QUESTIONS & RESPONSES #01

RFQ TITLE 071645 | FABULICH CENTER BUILDING ENVELOPE RESTORATION

Q&A ISSUE DATE 5/16/2022 @ 4:00 PM (PST)

7 STOREFRONT SILL AT PLASTER

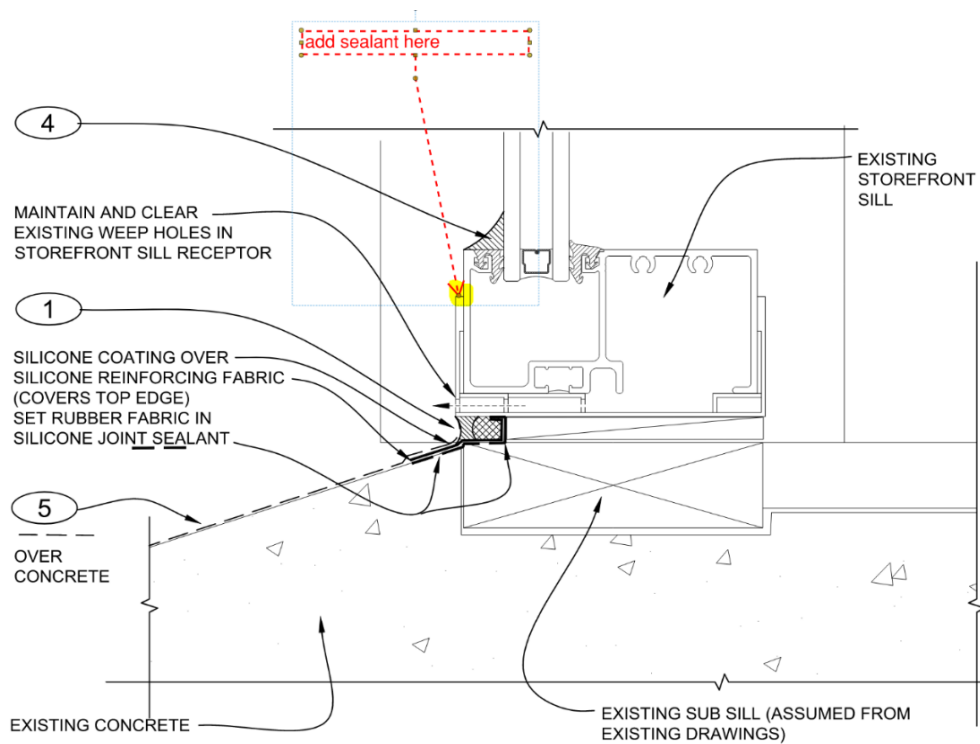
The detail of the fillet joint where the sill/header meets the window system is misleading. One detail 7/W3.01 shows it very simply as a fillet, probably standard. Whereas 3/W3.02 indicates it should be installed per 9A/W3.01 which is like a massive cove joint more in line with a wet seal application.	“Bond break tape is not needed at the small sealant fillet as noted on repair keynote 1, delete this scope. Add the fillet sealant/band aid over receiver” scope to detail 10 on W3.01 to match detail 7 on sheet W3.01.” The small fillet sealant/ band aid is not need at detail 3 because it has overhead protection. See diagram on page 2.	W3.01
The fillet joint where the sill/header can meets the window system is only shown as being addressed where there is plaster below at the sill location (Detail 7). It is not shown being addressed at the Head (Detail 3) or Sill at concrete base (Detail 10). Since it's a small item I'd prefer to get everyone bidding it the same way.	“Bond break tape is not needed at the small sealant fillet as noted on repair keynote 1, delete this scope. Add the fillet sealant/band aid over receiver” scope to detail 10 on W3.01 to match detail 7 on sheet W3.01.” The small fillet sealant/ band aid is not need at detail 3 because it has overhead protection. See diagram on page 2.	W3.01
